Project	Cliffe Lane, Gomersal -Application Number 2023/92966	Document No	152130-006-001
Subject	Technical Note - Highway Response to comments received

The purpose of this Technical Note is to review the highway comments and the concerns raised in relation to the proposed site access. This Technical Note will seek to address and clarify the highway concerns raised.

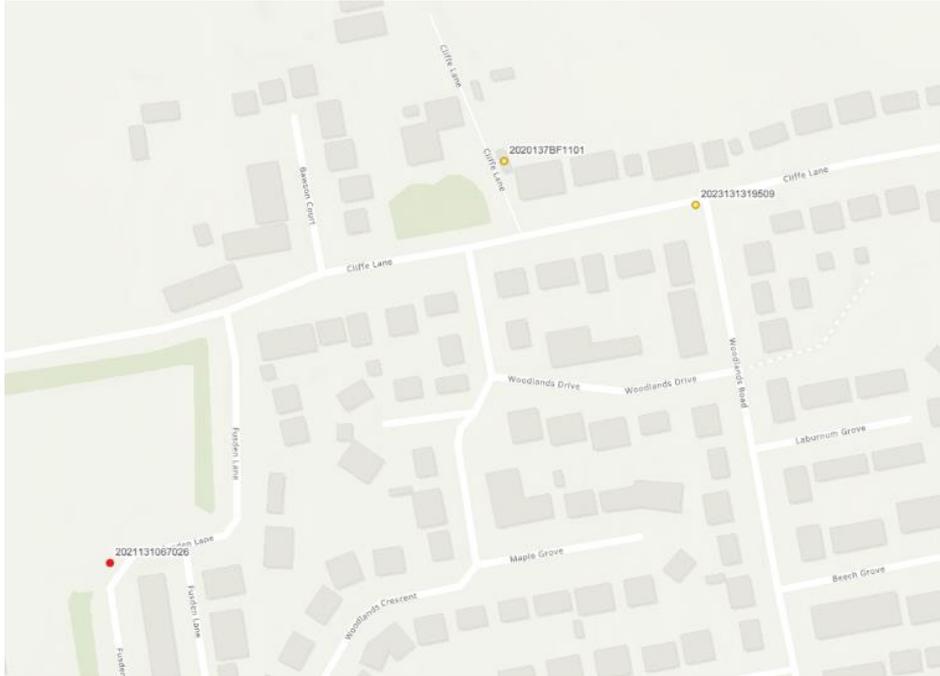
The Section 38 Adoptions Team Engineers comments are “the RSA1 Designers Response has not accepted the RSA Recommendation which is not acceptable. The previous RSA was rejected because it was over five

years old and whilst the Developer has claims this was previously accepted our design standards have moved on since and hence the new RSA Recommendations will need to be resolved”.

The RSA raised two points, the RSA response accepted one point and did not accept the other point. The RSA response to the point not accepted stated.

The design team have provided some further justification for not accepting this comment.

Kirklees Highway Design Guide was adopted in November 2019. The roads within the site are classed as Local Residential Street (Type B). **Table 5: Recommended guidelines for junction radii and visibility layouts**, identifies that the access should be provided with 6m radii. It can be confirmed that the site access junction onto Cliffe Lane is provided with 6m radii and is provided in accordance with recommended guidelines. Whilst it is noted that the Highway Design Guide was adopted in November 2019, 8 months after the original RSA was completed, it is understood that the geometry requirements were unchanged from the council’s previous guidance. Consequently the council comment in this respect is considered to be irrelevant.

Manual for Streets guidance was first issued in 2007 and therefore this guidance was appropriate at the time of the first application and its consideration by the council and remains appropriate today.

Other access points along Cliffe Lane are also provided with similar geometry. Woodlands Crescent, Woodlands Road and Fusden Lane are just three examples. A review of the Crashmap Pro collision analysis system for a period covering from 2014 to December 2023 (9 years of data) shows that no accidents involving goods/refuse vehicles have occurred at these three junctions. All three junctions detailed would require the refuse vehicle to turn in and out of these junction in a similar manor to the proposed access. The incident plot diagram within the vicinity of the site is shown overleaf:
